1636 Argonne Place, NW Existing Conditions

Front Elevation & Grade June 2015

1636 Argonne Place, NW Existing Conditions

1636 Argonne Place, NW

FRONT GRADE - Revised Plans, Proposed – East Elevation
Sheet A0201 (12/17/14) - Unchanged in Sheet A0201 (6/4/15)

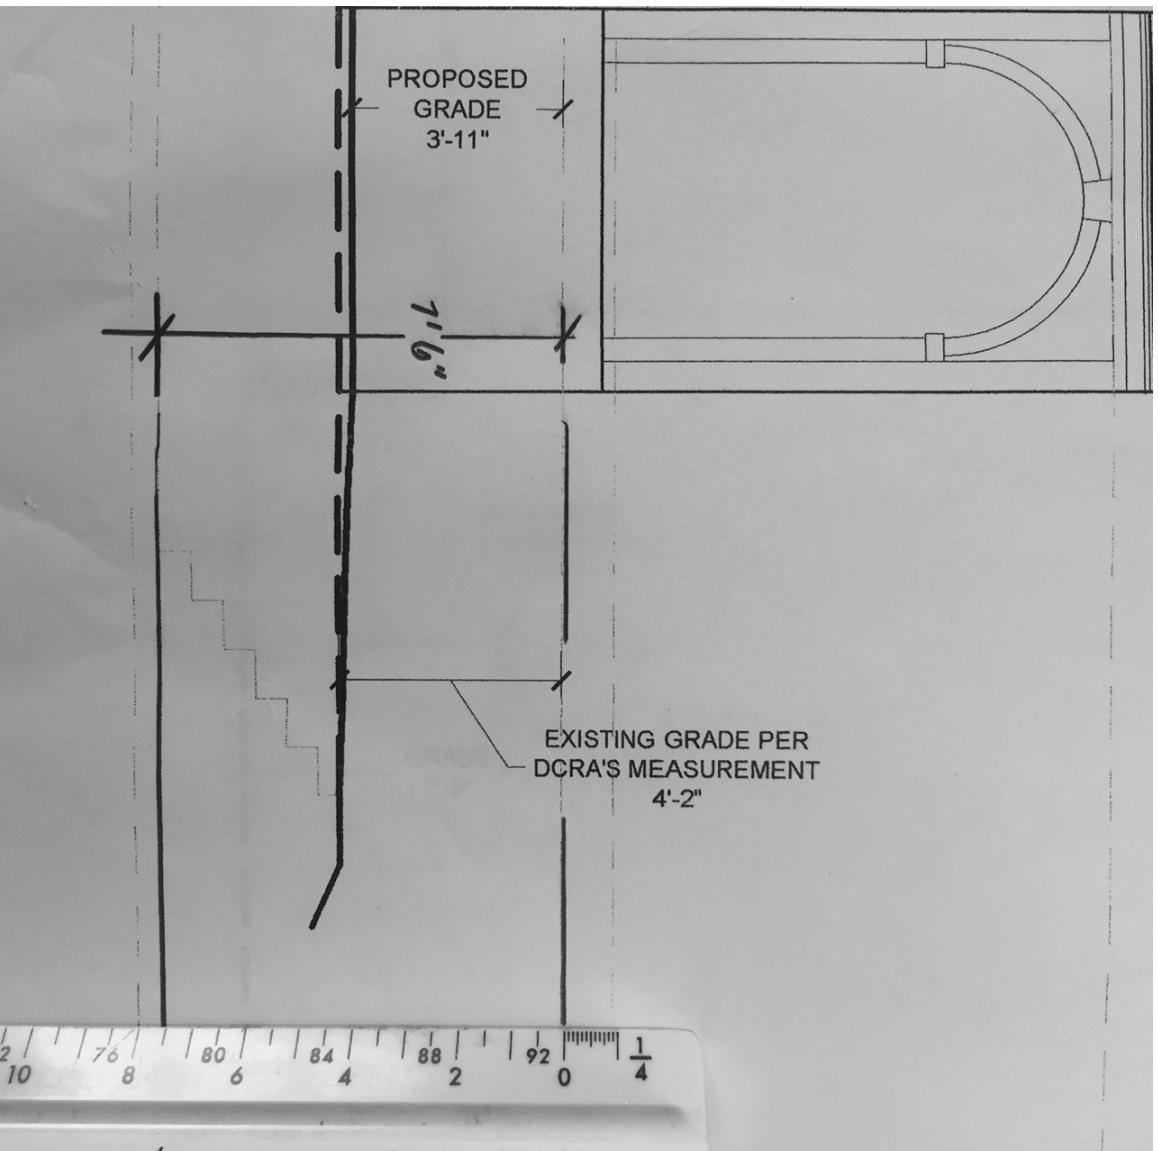
DCRA Notes Existing Grade as 4'2"

This Establishes Lower Level Front Grade as Basement
Drawing Misrepresents Proposed Grade as 3'11", which
Would be Impossible to Achieve as Space is Part of LL Unit

FRONT GRADE – Revised Plans, Proposed – West Elevation
Sheet A0202 (12/16/14) - Unchanged in Sheet A0202 (6/4/15)

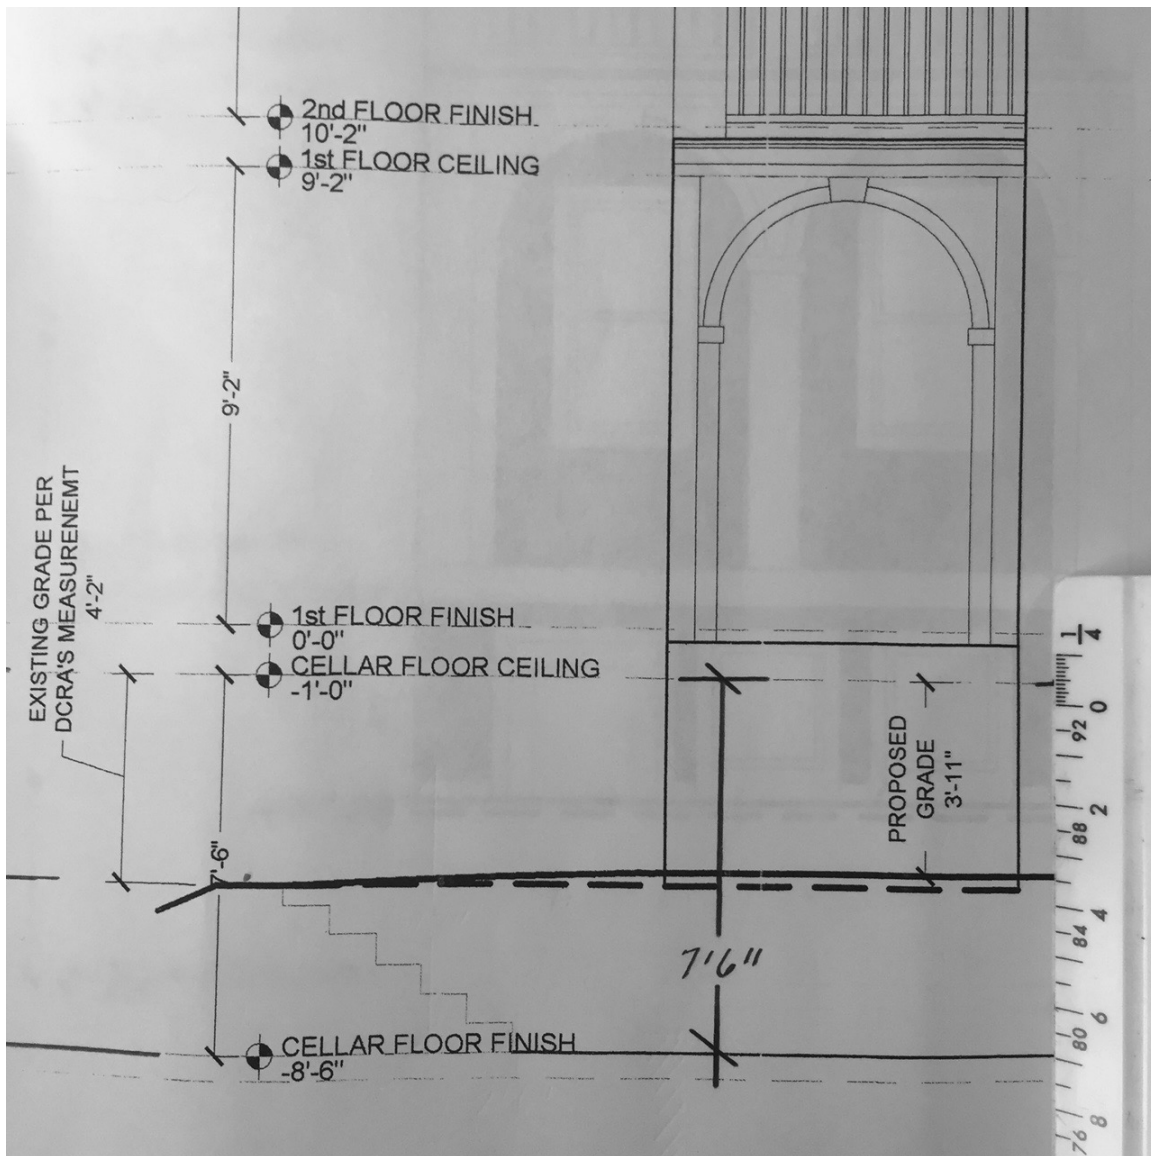
DCRA Notes Existing Grade as 4'2"
This Establishes Lower Level Front Grade as Basement
Drawing Misrepresents Grade as 3'11"

Sheet A0203 (12/17/14) - Unchanged in Sheet A0203 (6/4/15)

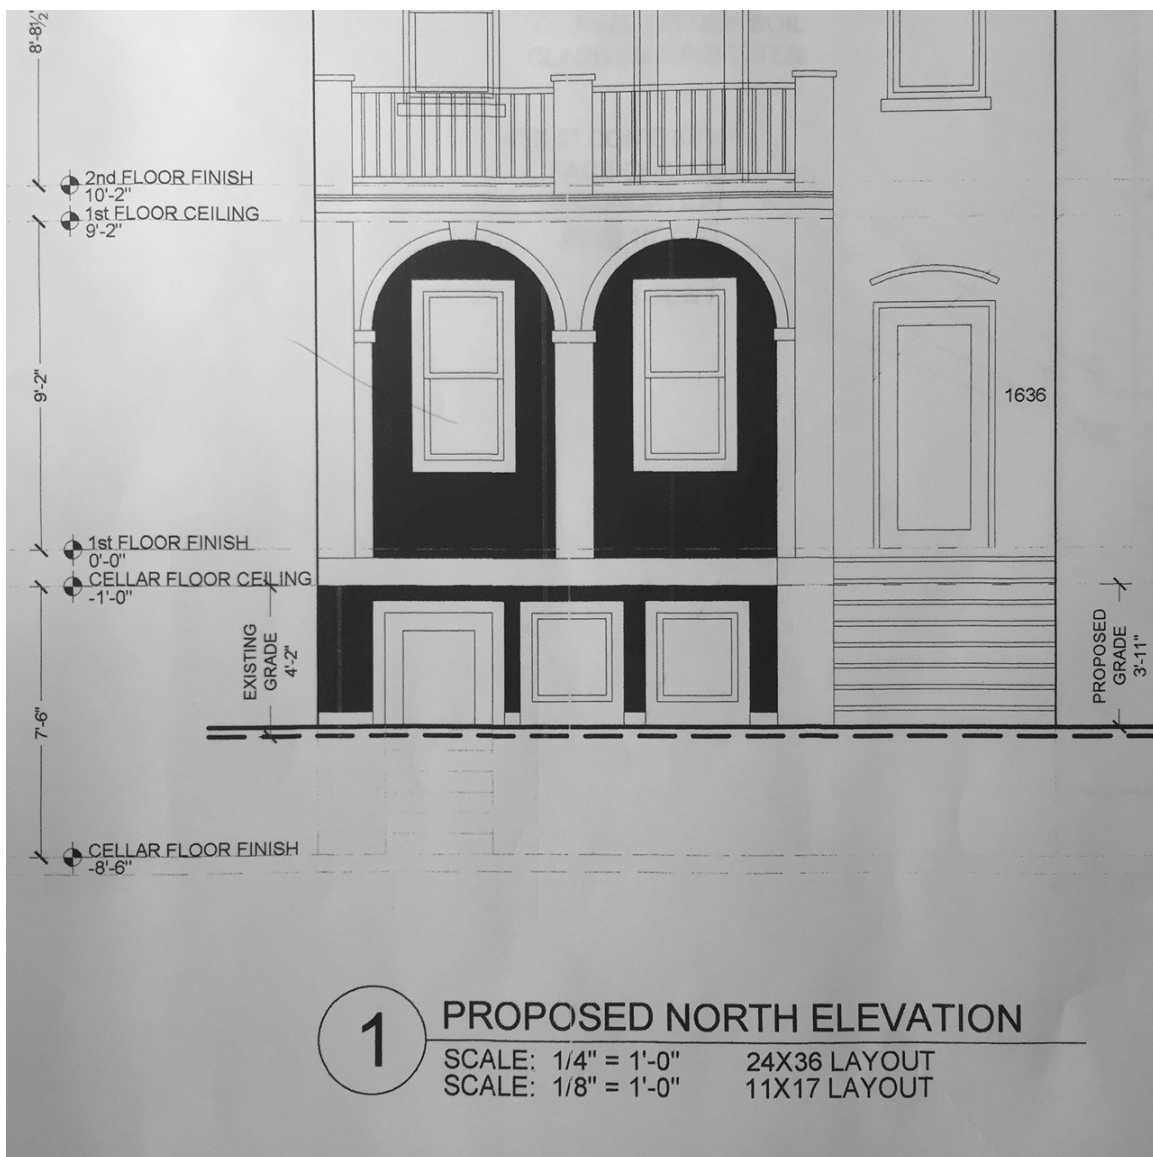
Existing Grade is Noted as 4'2."

This Establishes Front Grade as Basement
For Purposes of Calculating Existing FAR

Noting Proposed Grade of 3'11" is Moot for Purposes of Establishing FAR

FRONT ENTRYWAY - Revised Plans, Proposed
A0100 (12/17/14) - Unchanged in Sheet DDOE1 (6/4/15)

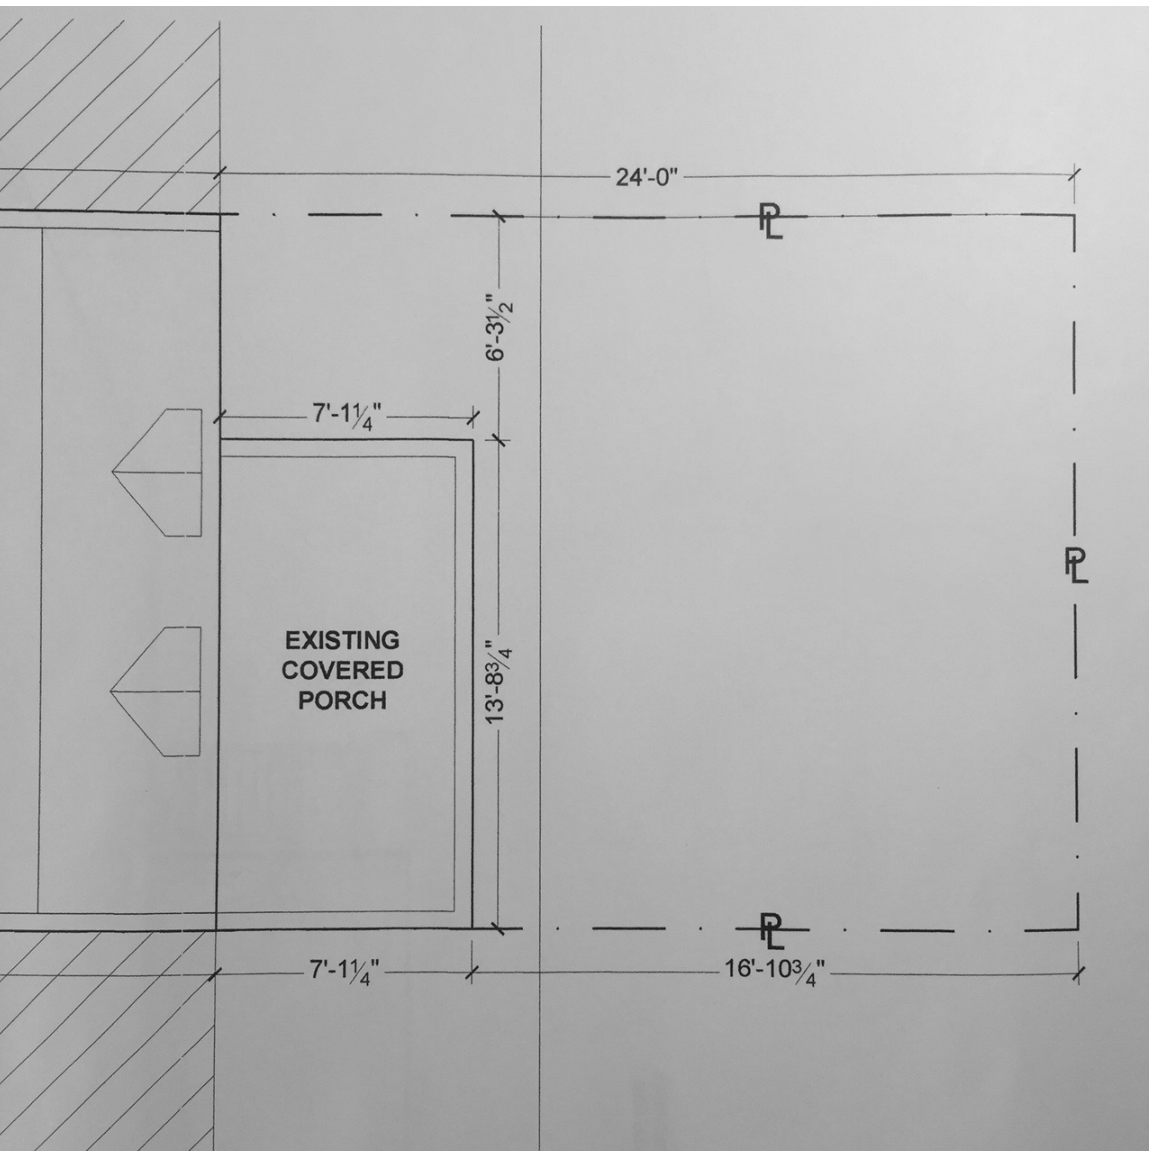
Entryway at Lower Level is 7 ¼ Width, 7" 6" Grade
Entryway is NOT Definable as Areaway and is Proper Point of Measurement

REAR GRADE- Revised Plans, Proposed - East Elevation
Sheet A0201 (6/4/15)

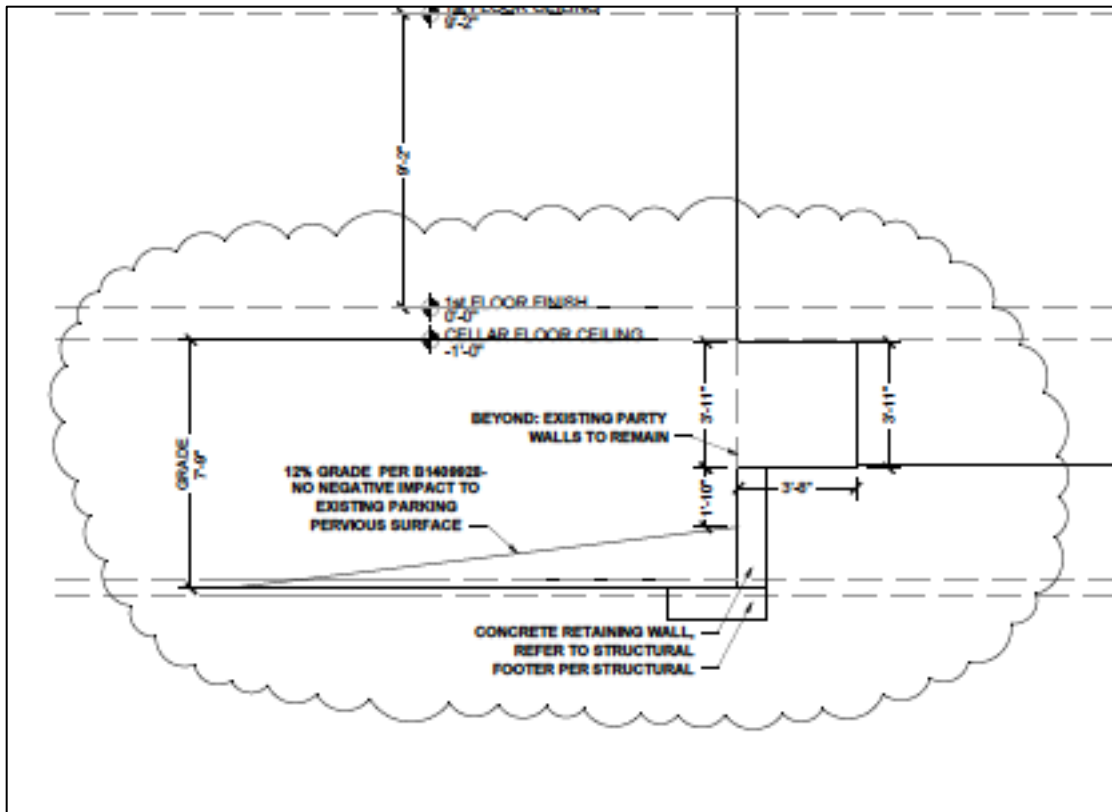
Existing Grade is 7'9", Establishing Rear as Basement Grade
Retaining Wall and Sloped Parking Do Not Exist as of 6/23/15
3'11" is within Building and Not Definable as Adjacent Finished Grade
Grade is 5'9" as Measured from Un-built Slope to Ceiling of Lower Level

A0203 (6/4/15)

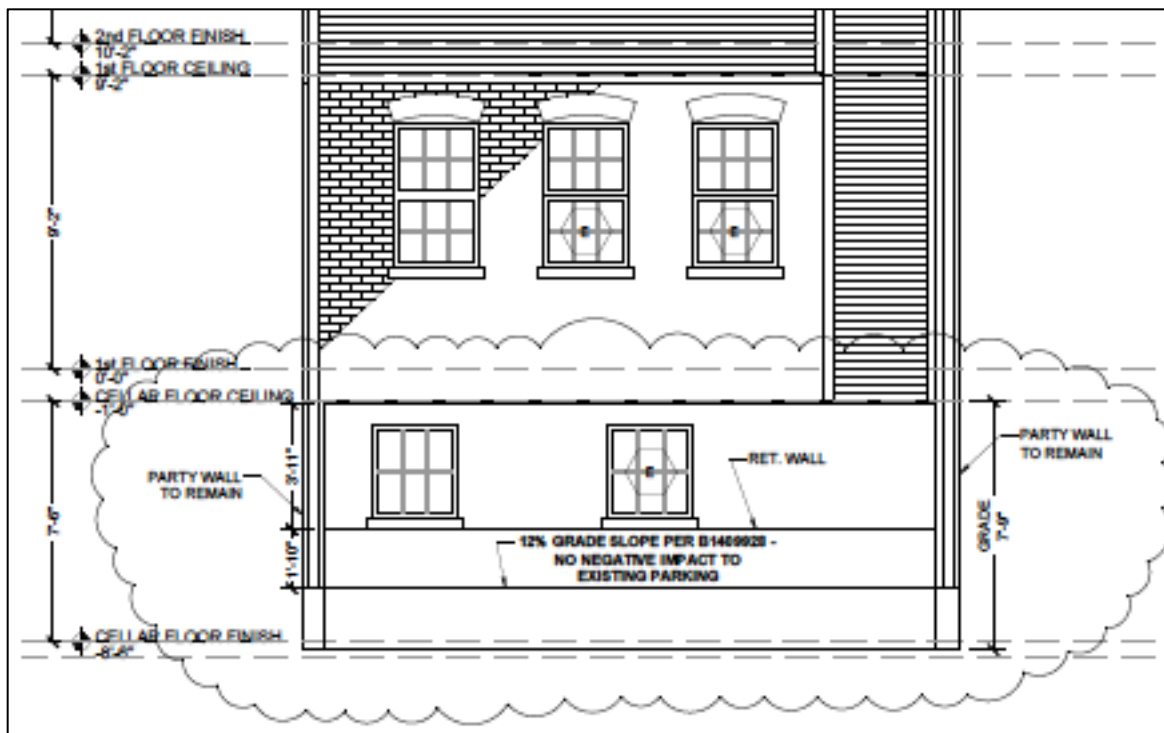
Existing Grade is 7'9", Basement Level

Retaining Wall and Sloped Parking Do Not Exist as of 6/23/15

3'11" is within Building and Not Definable as Adjacent Finished Grade

Grade is 5'9" as Measured from Un-built Slope to Ceiling of Lower Level

Drawing Illustrates Windows of ~3'6" But 49" Windows are Currently Installed

A0203 (6/4/15)

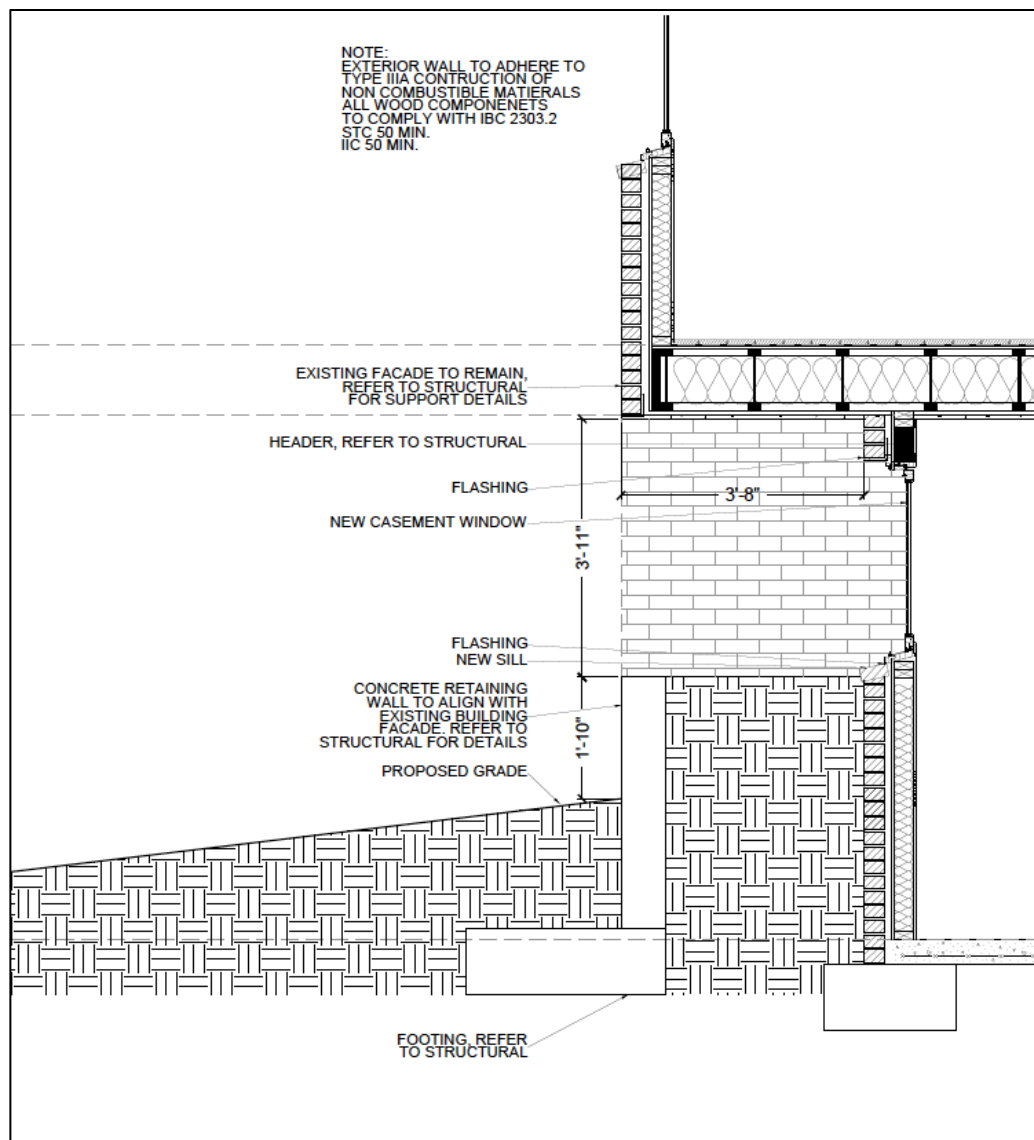
Retaining Wall and Sloped Parking Do Not Exist as of 6/23/15
3'11" is within Building and Not Definable as Adjacent Finished Grade
Grade is 5'9" as Measurement from Point Defined as "Proposed Grade"
Drawing Illustrates Embedded Windows But 49" Windows are Currently Installed

PARKING – Revised Plans, Proposed – Upper View
Sheet A0100 (6/4/15)

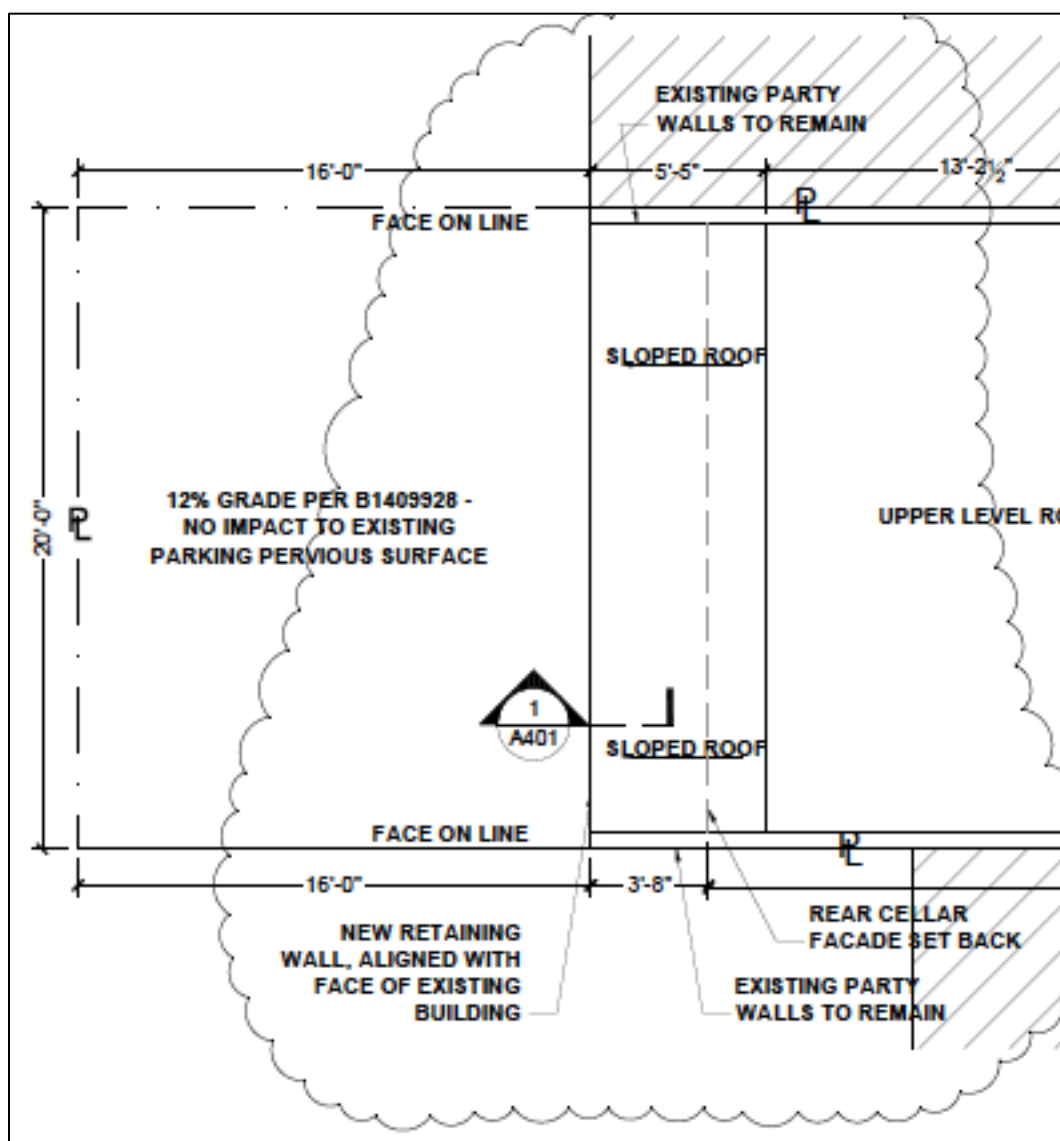
Current Parking Area is 16' Deep, Insufficient for 19' Regulation Spaces

Current Parking is NOT Pervious Surface But Rather is Concrete

12% Grade Parking is Non-Existent as of 6/23/15

12% Slope Worsens Already Non-Compliant Condition
